**RESOLUTION SETTING HEARING ON REQUEST FROM
AIRPORT DEVELOPMENT, LLC (DEVELOPER) FOR SECOND AMENDMENT TO THE
AIRPORT COMMERCE PARK SOUTH PUD CONCEPTUAL PLAN ON PROPERTY
LOCATED AT 7201 AND 7301 SOUTHWEST 22ND STREET**

AMENDED CONCEPT PLAN AIRPORT COMMERCE PARK SOUTH

SECOND AMENDMENT

REVISED REQUEST

FIRST AMENDMENT

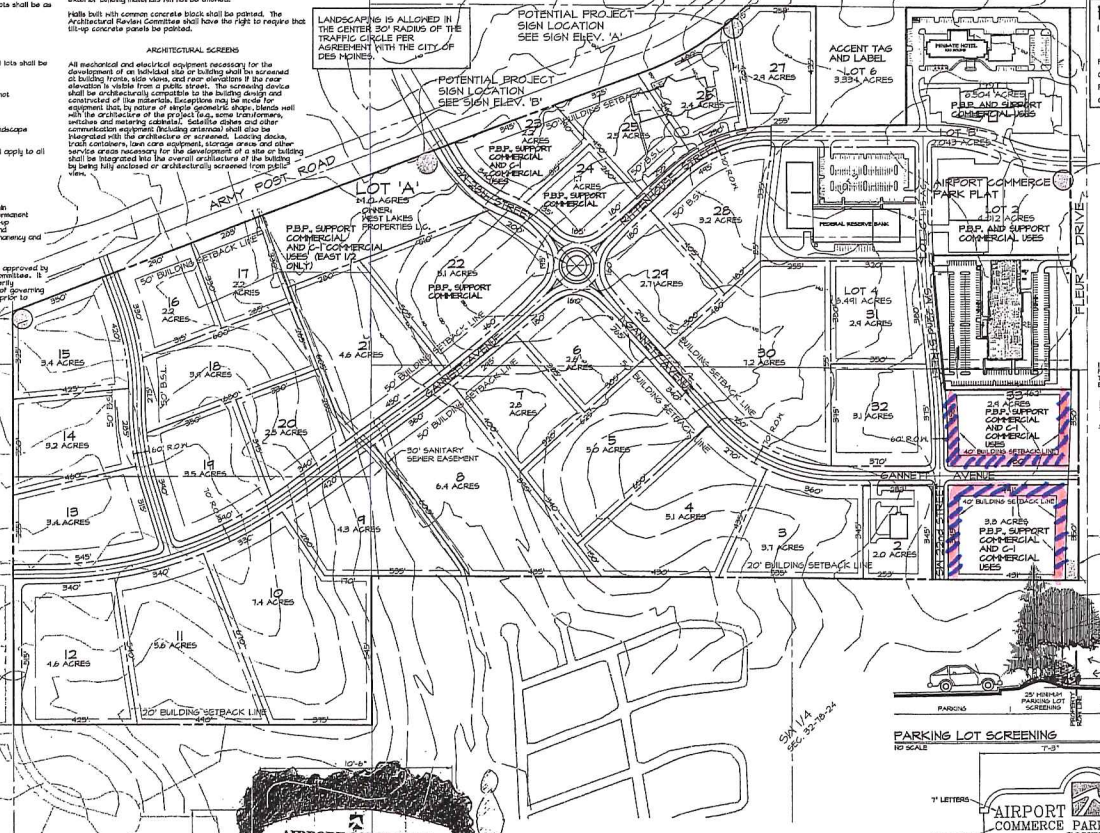
1. REVISE THE FRONT YARD SETBACK ON LOTS 1 AND 39 LOCATED AT GARNETT AVENUE AND FLEUR DRIVE FROM 50 FEET TO 40 FEET. 2. REVISE THE ZONING ACTION TO CITY COUNCIL APPROVAL. 3. REVISE THE ROLL CALL NUMBER. 4. REVISE THE ORDINANCE NUMBER.

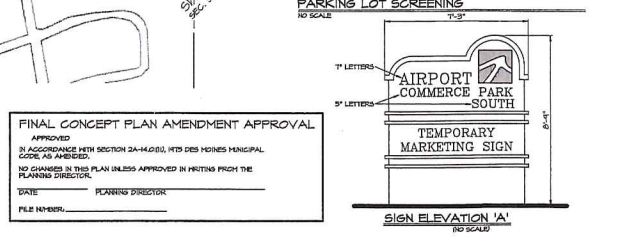
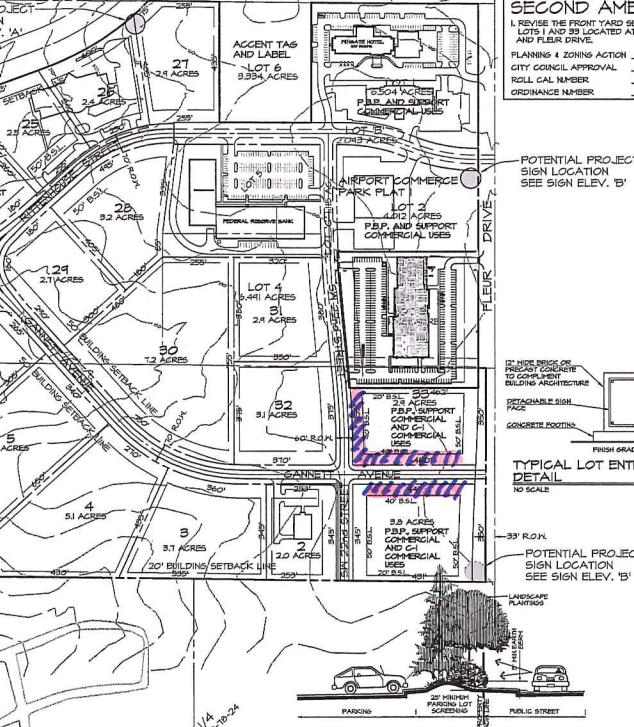
1. REVISE THE FRONT YARD SETBACK ON LOTS 1 AND 39 LOCATED AT GANNETT AVENUE AND FLEUR DRIVE.

- Building Setback:
 - Front - 40 feet
 - Side - 20 feet
 - Side - 20 feet, 3' minimum one side
 - Setbacks for all other C-1 and PBP support commercial lots shall be as follows:

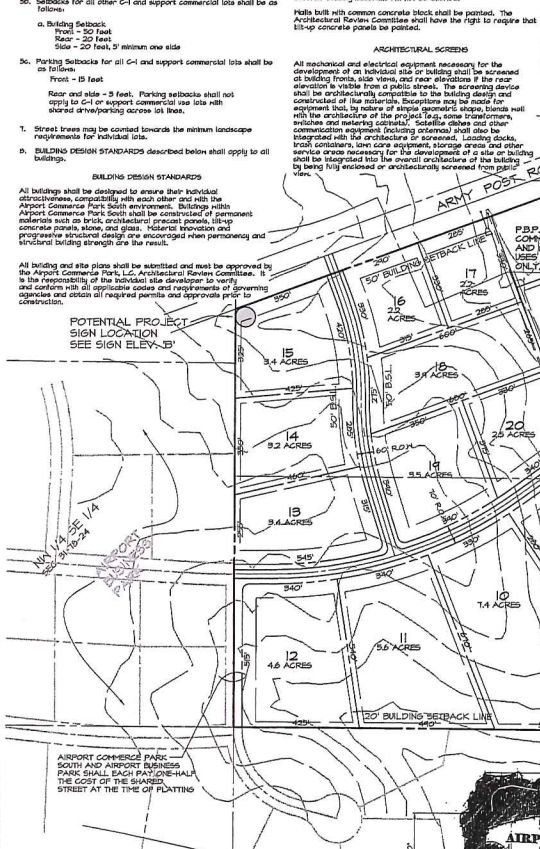
1. REVISE THE FRONT YARD SETBACK ON LOTS 1 AND 93 LOCATED AT GANNETT AVENUE AND FLEUR DRIVE.
